SAN FRANCISCO PLANNING DEPARTMENT

Executive Summary Amendments to Design-for-Development

Date: October 17, 2019
Case No.: 2007.0946CWP-03
Project Address: **Candlestick Point**
Zoning: Candlestick Point Activity Node Special Use District
Location: *Candlestick Point*
Project Sponsor: Kofi Bonner
FivePoint
1 Sansome, Suite 3200
San Francisco, CA 94104
Staff Contact: Mat Snyder – (415) 575-6891
Mathew.snyder@sfgov.org

REVISIONS OCTOBER 2019

Figure 5.5 Candlestick North – Urban Design

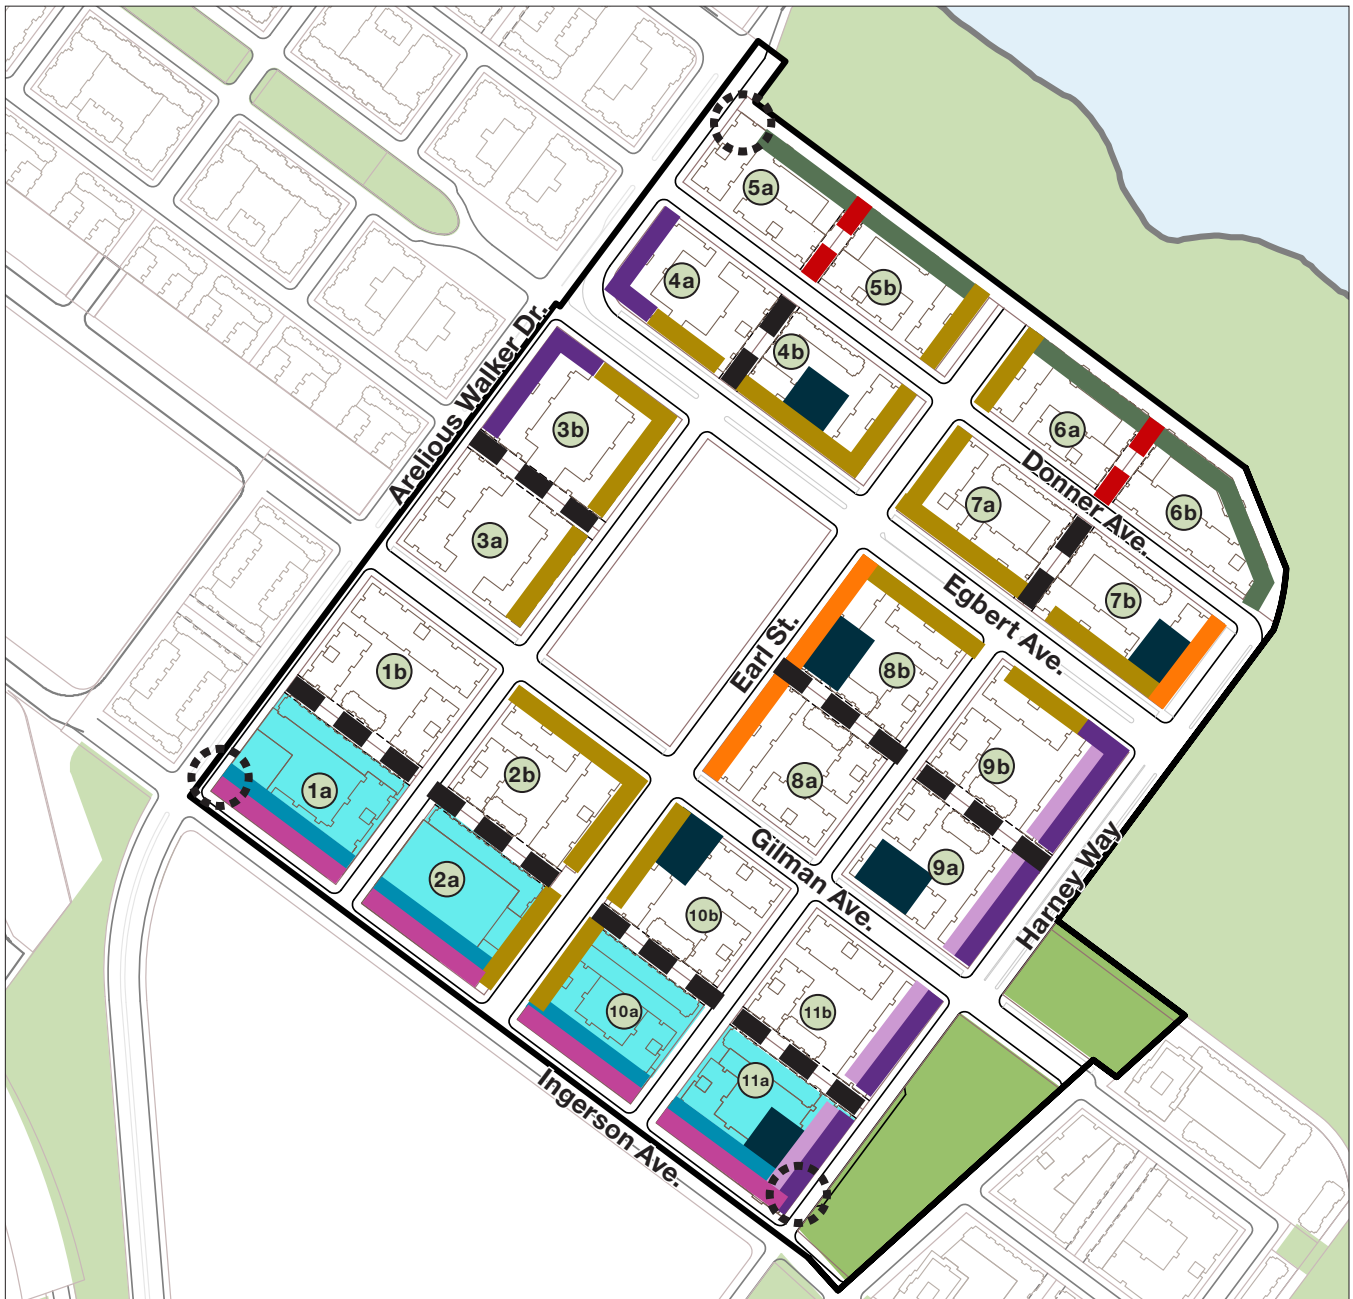
FIGURE 5.5 IS REPLACED- PREVIOUS CANDLESTICK CENTER STREET NETWORK REPLACED

Figure 5.911 Candlestick South Urban Design

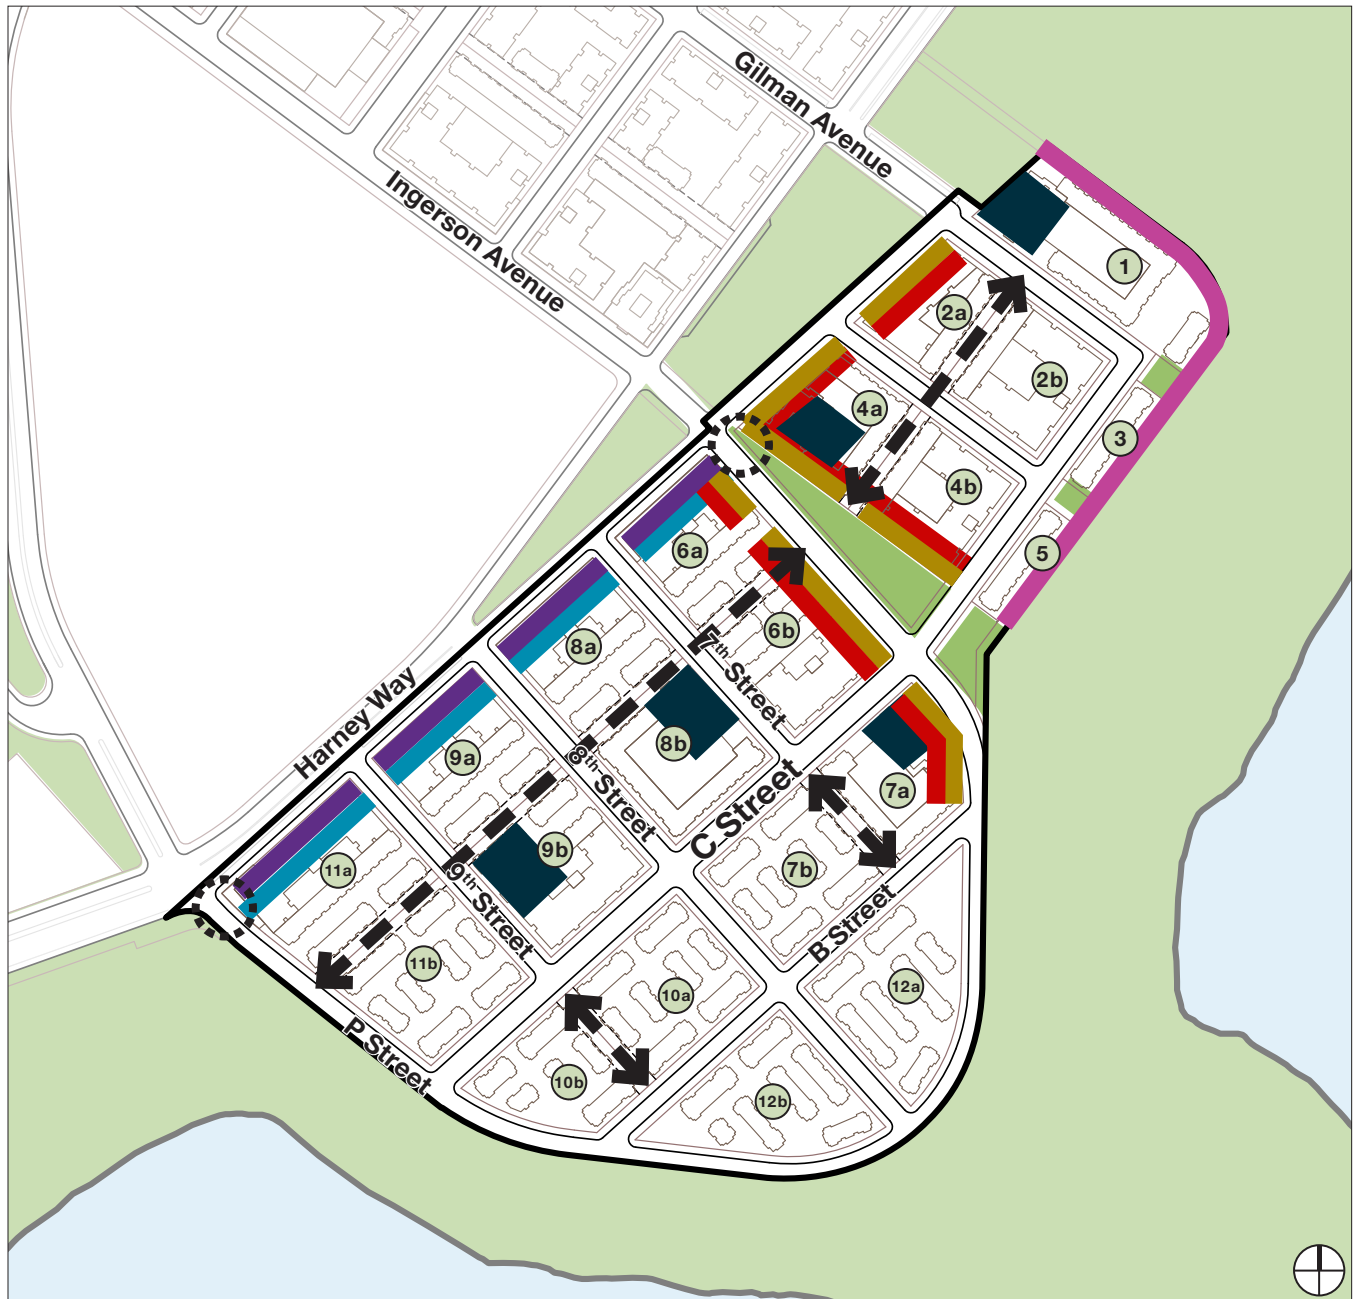
FIGURE 5.11 REVISED – CANDLESTICK CENTER REPLACED IN BACKGROUND

Figure 7.2 Building Heights

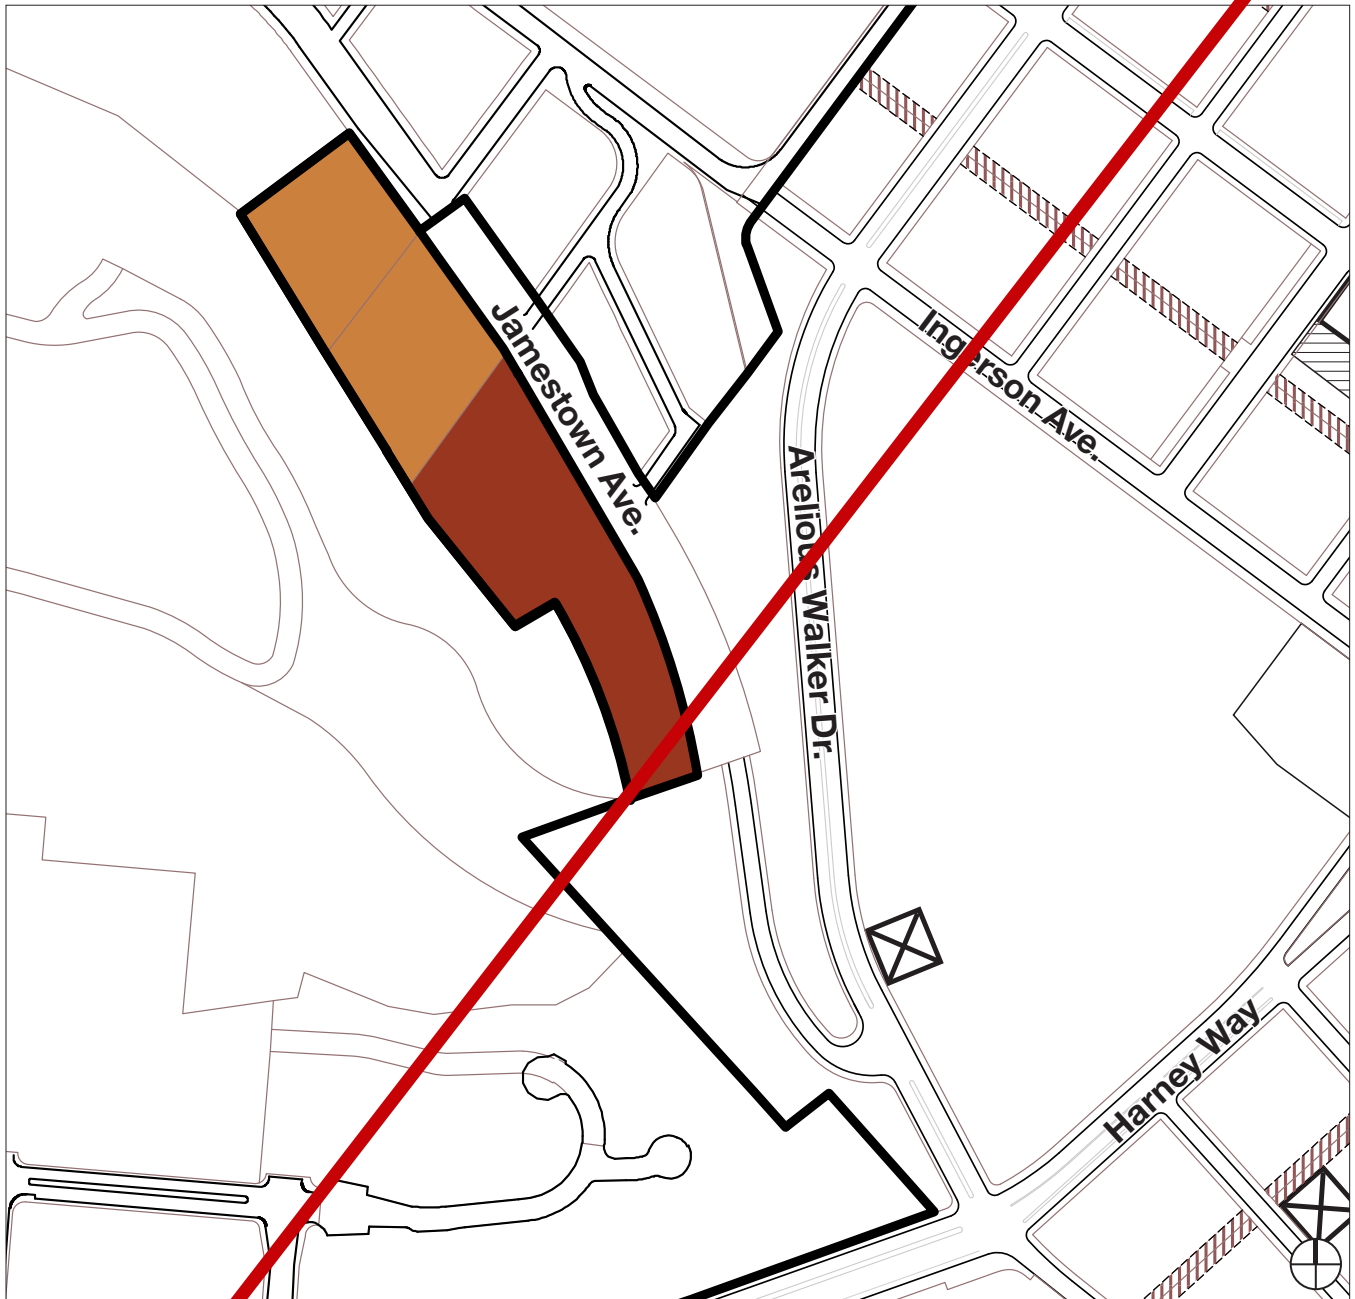
CHAPTER DELETED

Figure 7.3 Street Wall Conditions

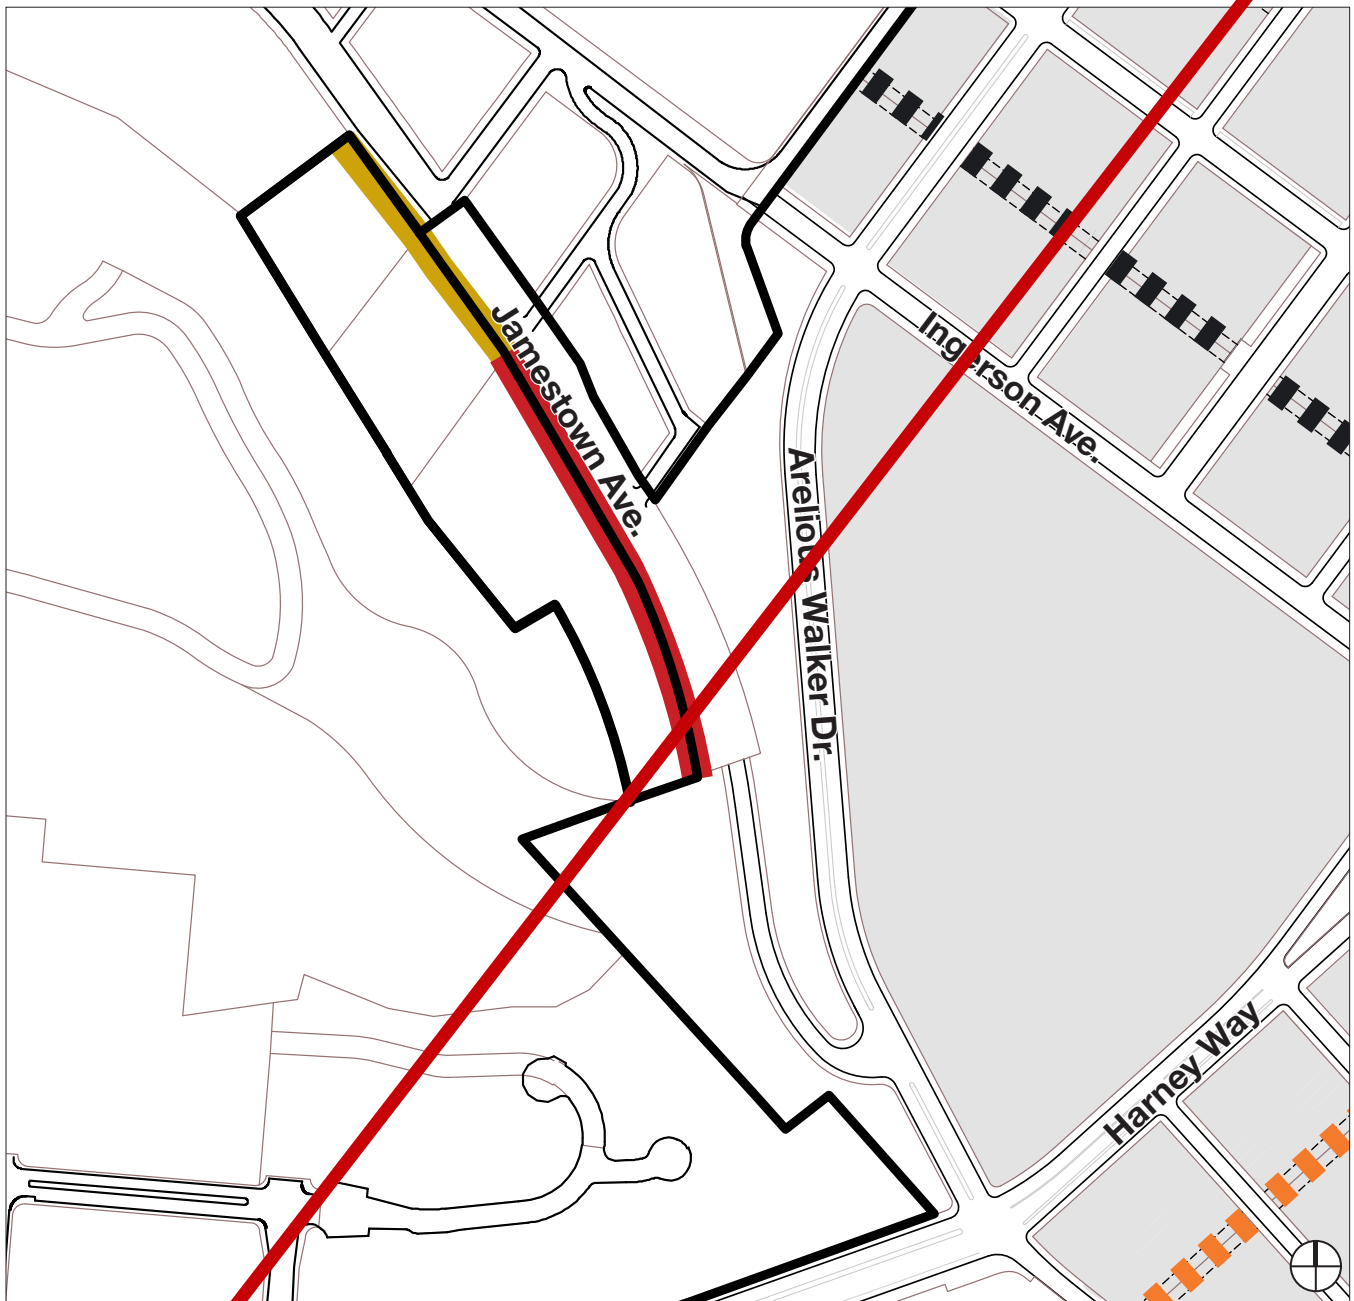
CHAPTER DELETED
